Field Notice

HysteroLux™ Fluid Management System Control Unit – REF 72205000

WOM reference no.: 2021-0002

Field Notice
HysteroLux™ Fluid Management System Control Unit — REF 72205000

Figure 1 Pump Control Unit display showing the calculated deficit (Deficit display) and inflow volume count (Total Inflow volume display). The latter will freeze, once 32,450 ml has been reached.

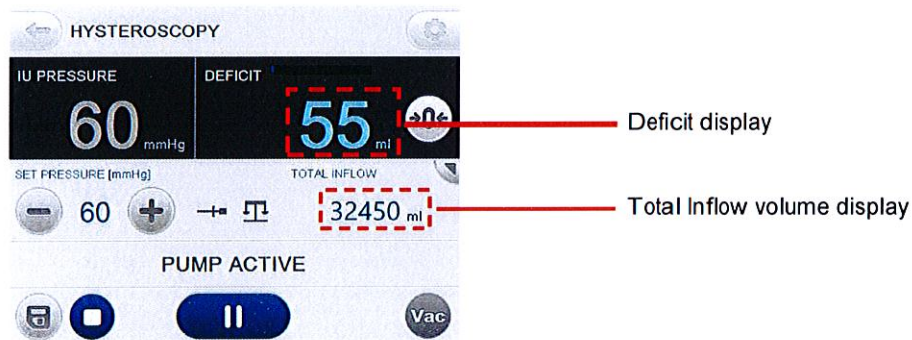
This field notification is being issued following reports from customers from the USA that the display of inflow volume on the HysteroLux™ Fluid Management System can reach its limit of 32,450 ml during long procedures. In these cases, the display does not indicate the actual inflow volume. In cases where an unusually high amount of fluid is used for distension of the patient's uterus, the calculation of the inflow and outflow volumes reaches its limit and the Control Unit display will freeze at the maximum value.

Our investigation has identified a software anomaly as the cause for this display freeze. The reason for this is that at 32,450 ml an internal software calculation threshold is being reached. As the outflow measurement will continue, the result is that the deficit accumulated up to this point will start counting backwards until 0 ml is reached.

This incorrect display of fluid inflow can result in fluid overload. Fluid overload can be affected by distension pressure, flow rate and duration of the hysteroscopic surgery. It is critical to closely monitor the inflow and outflow of the distending fluids at all times. The pressure should be kept as low as possible to allow for a sufficient intrauterine distension and to reduce the forces that could allow fluid, ambient air, and/or gas into the circulatory system.

W.O.M. WORLF OF MEDICINE GmbH has developed a software version, which, when an inflow volume of 28.000 ml is reached, alerts the user that the limit is being approached and is designed to prepare the user for a manual determination of the deficit.

The new software version is implemented during the next preventive maintenance of your HysteroLux™ Fluid Management System Control Unit. If you wish to update the software of your device at an earlier date, please contact your sales representative of Medtronic Inc., who will assist in returning the unit and providing an exchange unit.
